**PLANNING COMMISSION MEETING  
AGENDA  
CITY OF WHITE BEAR LAKE, MINNESOTA**

**TO:** The Planning Commission

**RESOLUTION APPROVING A  
PLANNED UNIT DEVELOPMENT AND  
PRELIMINARY PLAT OF  
ROSE'S PARK VIEW ADDITION AT  
1788 COUNTY HIGHWAY 96 EAST  
WITHIN THE CITY OF WHITE BEAR LAKE, MINNESOTA**

# ROSES PARK VIEW ADDITION PRELIMINARY PLAT

# LOT LINE AND FENCE LINE DRAWING

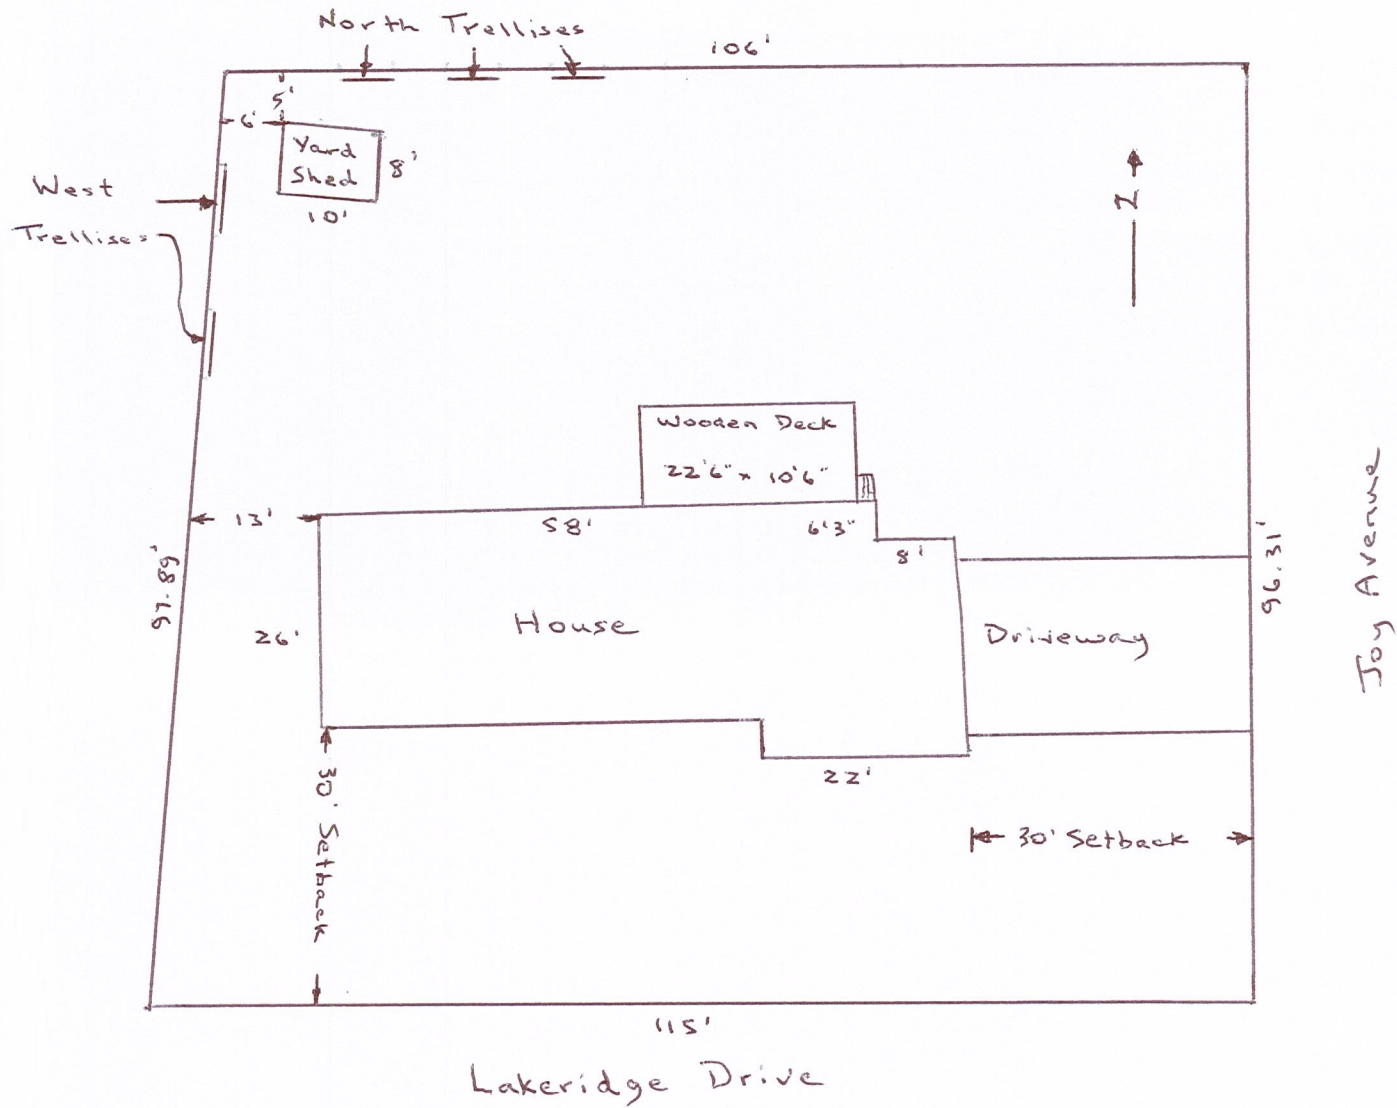
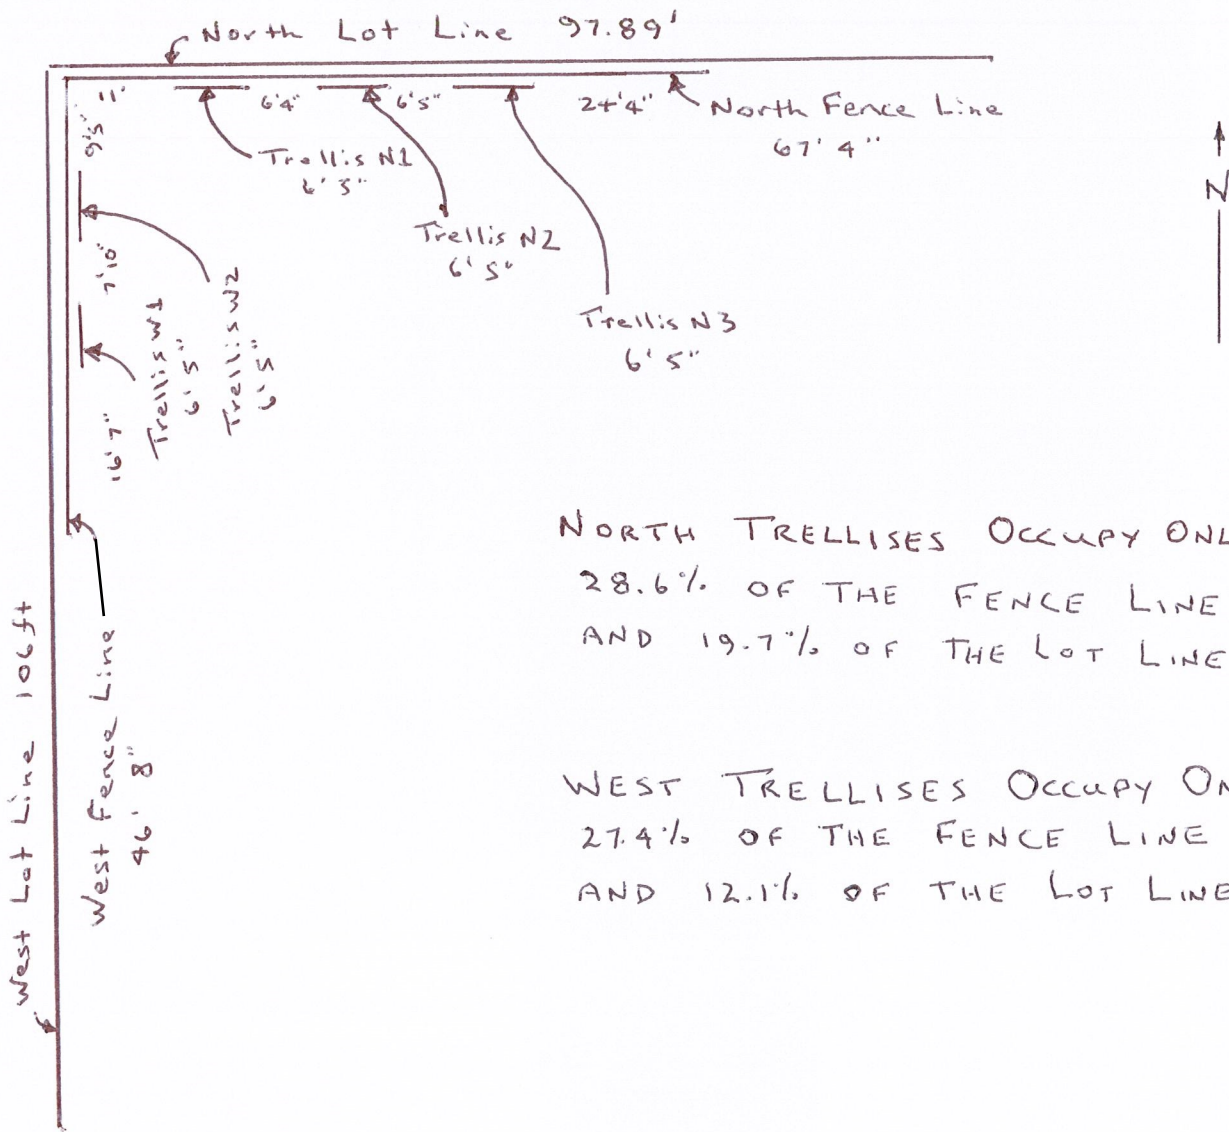
The panels are open with latticework and are not a solid wall. As the applicant states, the panels only constitute a little over a quarter of the northern and western fence lines and there is space between each panel. Vining plants and other landscaping have been incorporated around the sections to soften their appearance. Because of these characteristics, staff agrees with the applicant that the panels could be classified as trellises.

The inspector suggested that we should have the contractor remove two feet off the top of each trellis to bring them into compliance. The trellises would then be 6' by 6' and look unattractive as well as not providing the effect we were aiming for.

Rather than add more cost to a project that is not a fence and has the support of all neighbors, we are seeking a variance. The trellises only occupy a small portion of the fence lines and lot lines and are clearly not a continuous structure.

SITE PLAN  
**C-101**  
PROJECT NO.  
**CLS21022**

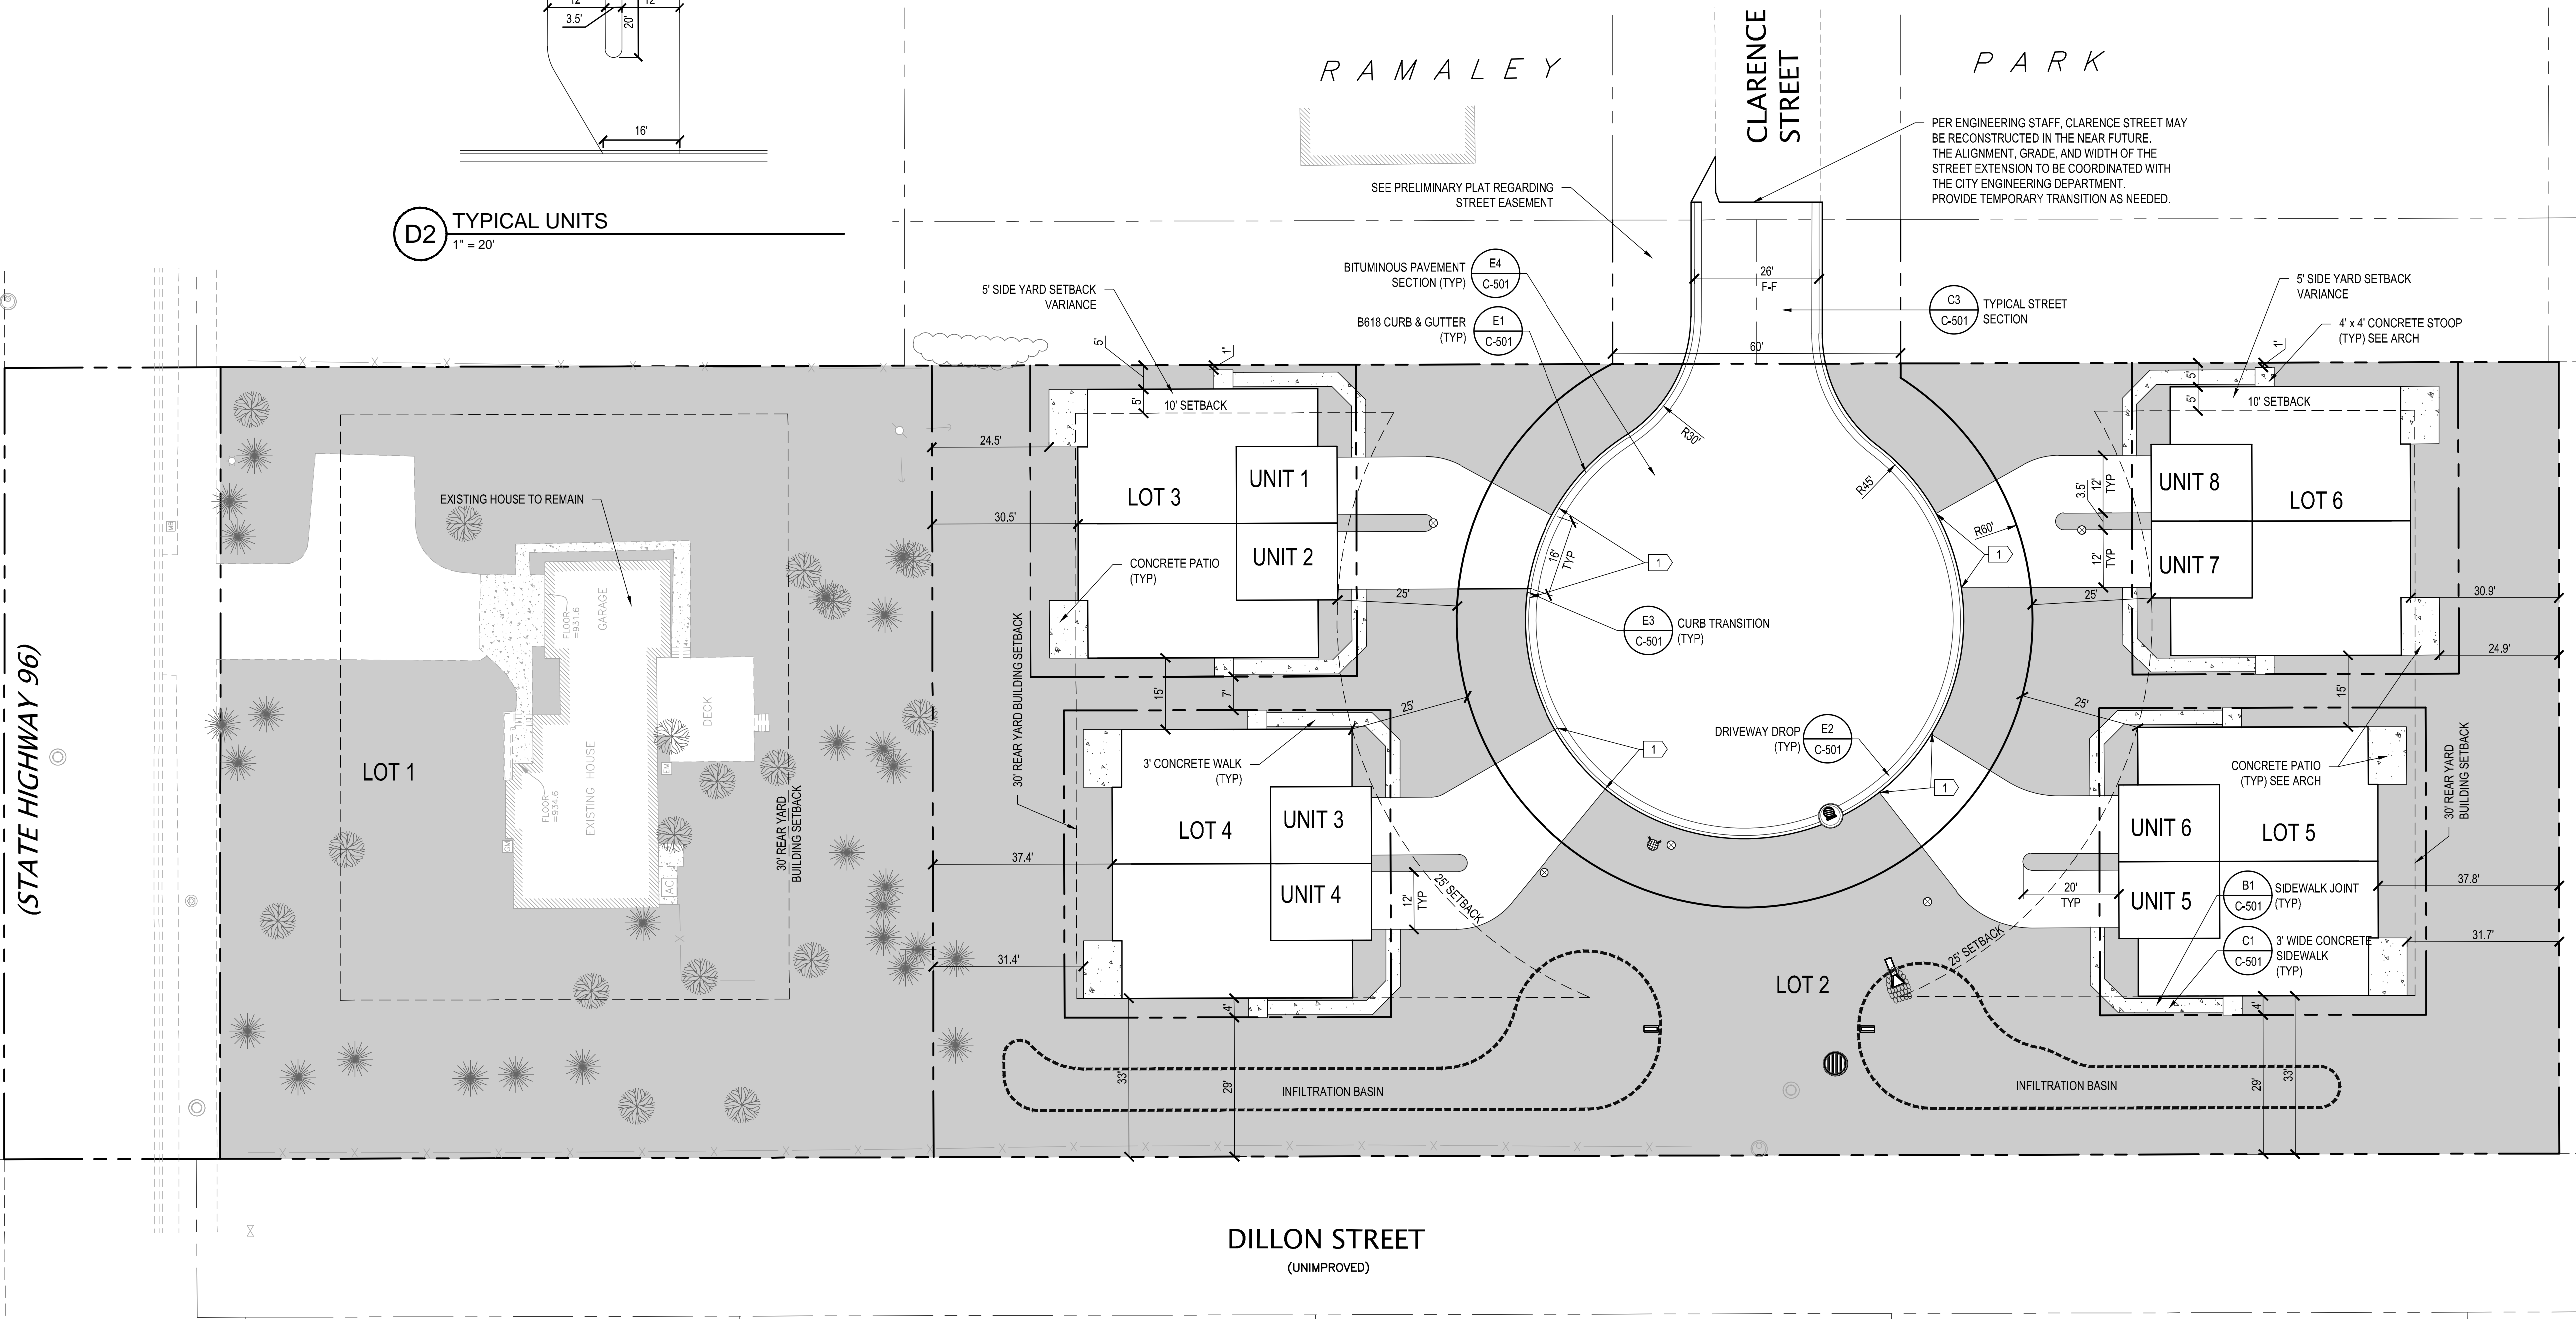
The proposed site design meets all setback requirements except for the 10 foot setback from the east property line. Staff does not support this deviation and has included a condition that the plan be revised to meet the 10 foot setback from the east property line.

11. No new construction may adversely impact the adjacent parcels with respect to drainage.
12. The site design shall be revised to meet the 10 foot setback from the east property line as required by code.

LANDSCAPE PLAN

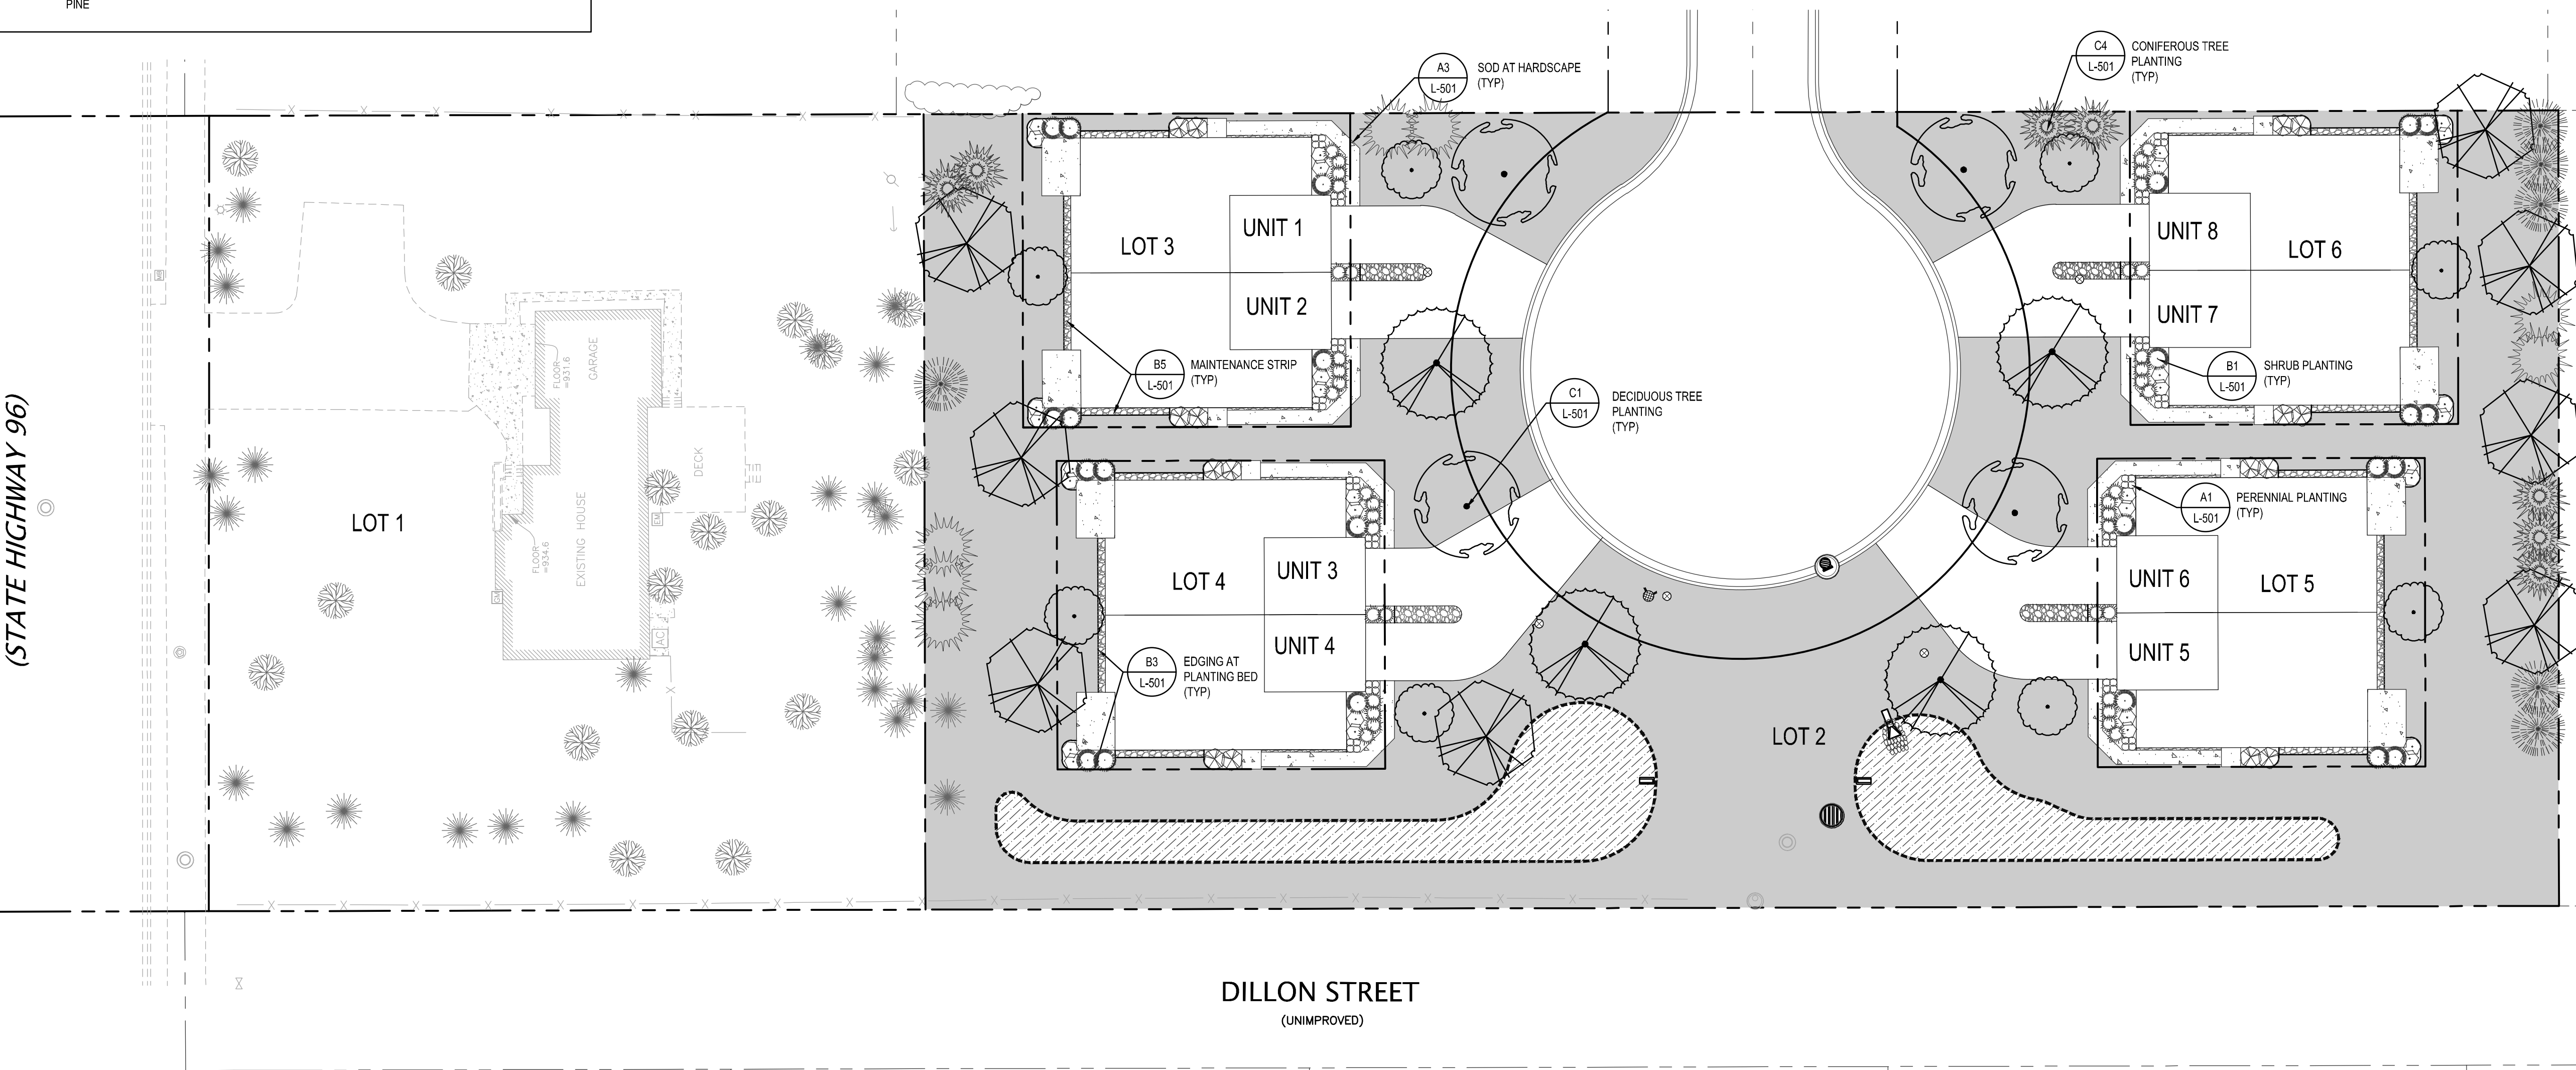
Unfortunately, all of the trees on site must be removed to accommodate the proposed development. The applicant will need to revise the tree replacement calculation to meet code.

Section 1406.030, Subd.6 of the Subdivision Regulations requires street trees (trees planted in the city's right-of-way) at the rate of one per lot. The plans propose some trees that are very close to but not actually in the right-of-way. These would be acceptable, but they are already being counted as replacement trees, and they cannot be counted as both.

40) Landscape note 4: Provide a specification sheet for the MPCA filtration planting media for review. This media shall be consistent with the filtration media called out in detail E3 on sheet C502.

13. The project shall comply with the Fire Memo dated September 27th and the Engineering Memo dated October 7, 2021.
14. At least one tree per lot shall be planted within the right-of-way, in addition to the tree replacement requirement of the zoning code.

22. Black Locust trees are not exempt from tree replacement; the tree replacement calculation shall be revised to comply with code.
